## Delaware County Mental Health Facility

### **Construction Questions**

May 31, 2022

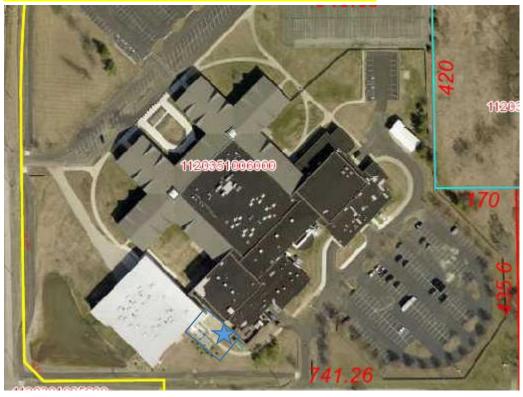
Please provide a current site plan that shows any improvements, to be used in locating exterior recreation space. How many patients would be allowed to use the recreational facilities at any given time?

THE COMPLEX IS LOCATED AT 3100 S. TILLOTSON AVE. AND IS AVAILABLE ON THE COUNTY'S WEBSITE. THE AREA IS AS FOLLOWS:
